Hyattsville Accessibility Transition Plan

SKATESPOT
ADDITION
AND
SITE
RENOVATIONS
@
MELROSE
NEIGHBORHOOD
PARK
(SKATESPOT)

SHEET TITLE
CONCEPT PLAN

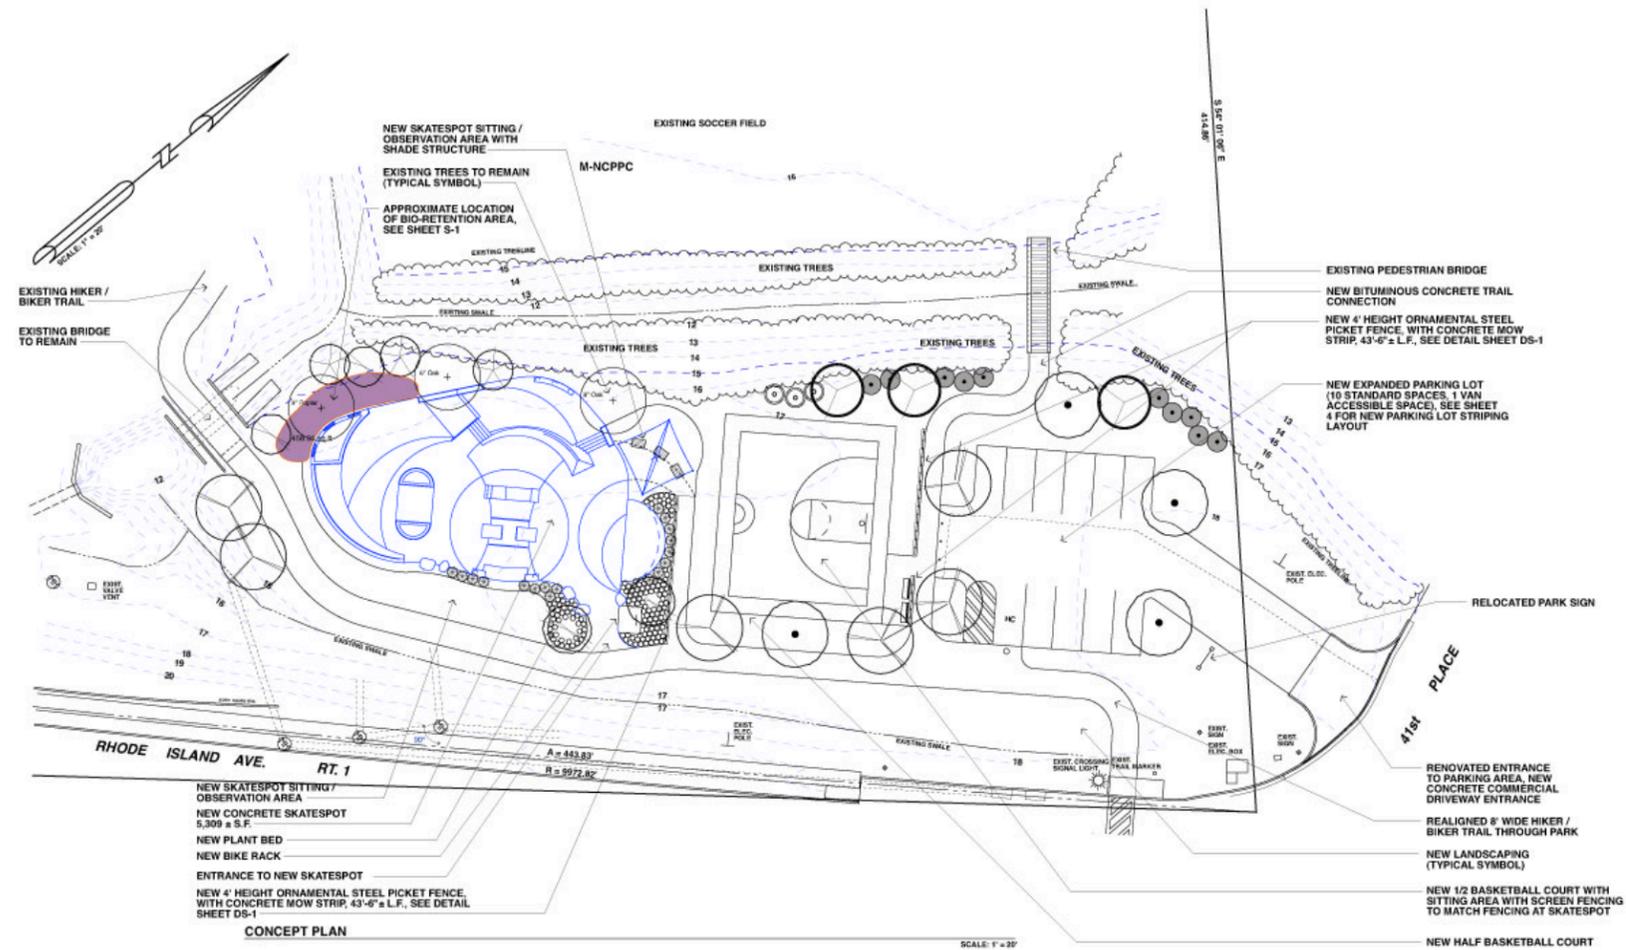
Melrose Park - Hyattsville Transition Plan									
Address: 41st Place and Rhode Island Avenue									
	2010 Standards Citation	Description/Issue/Requirement	Non-Complying Item	Photos	Proposed Solution	Suggested Priority	Projected Cost Hyattsville	Projected Date	Action and Date
1									
2		Accessible Route from Parking to the Playing Field							
3	208.2, 502.2, 502.3.1	An accessible parking space must have a 60" wide access aisle that extends the entire length of the parking space.	The original survey found that at the accessible parking space, the access aisle is less than 60" wide for the length of the parking space (corner cut off).	3208, 3212	Since the original survey, new construction by MNCCPC has changed the parking lot. It is assumed new parking is compliant.		\$0		
4	206.1, 302.1	Accessible route must be firm, stable, and slip resistant.	The accessible route from the parking lot (unfinished construction) to the bridge is not paved.	6865, 6866	New construction by MNCCPC has verified that an accessible route will be provided to the level of the bridge from the parking lot.		\$0

5	206.1, 302.1	Accessible route must be firm, stable, and slip resistant.	The accessible route from the bridge to the playing field is not paved. This route will require a ramp to meet bridge level .	6865, 6866	Provide an asphalt path from the bridge level to the playing field. Grade the accessible route or provide a ramp to reach the level of the bridge .	11	\$10,300		
6	226.1, 302.1	Bleachers are provided. Wheelchair spaces must be provided with the bleachers. The clear ground space must be stable, firm, and slip-resistant.	At the playing fields, the wheelchair space adjacent to the bench is not paved.	3184	Pave one wheelchair seating space adjacent to the bleachers on each side of the playing field.	25	\$350		
7		Accessible Route from Sidewalk/Bus Stop to Park Path							
8	206.1, 302.1	Accessible route must be firm, stable, and slip resistant.	The accessible route from the top of the bus stop curb ramp to the park entry path is missing a piece of paving, and so it is not a continuous accessible route.	3142, 3143	Provide paved landing at the top of the ramp connecting to park path system.	18	\$350

9	216.3, 703.5.6	Informational and directional signage must have a character height of 5/8" minimum.	The characters on the Greenway signage is 1/8".	3171	Provide new signage	21	\$250		
10					Total		\$11,250		
11									
12					Priority 1 - 4:		\$0		
13					Priority 5 - 9:		\$0		
14					Priority 10 - 14:		\$10,300		
15					Priority 15 - 19:		\$350		
16					Priority 20 - 25:		\$600		
17					Total		\$11,250
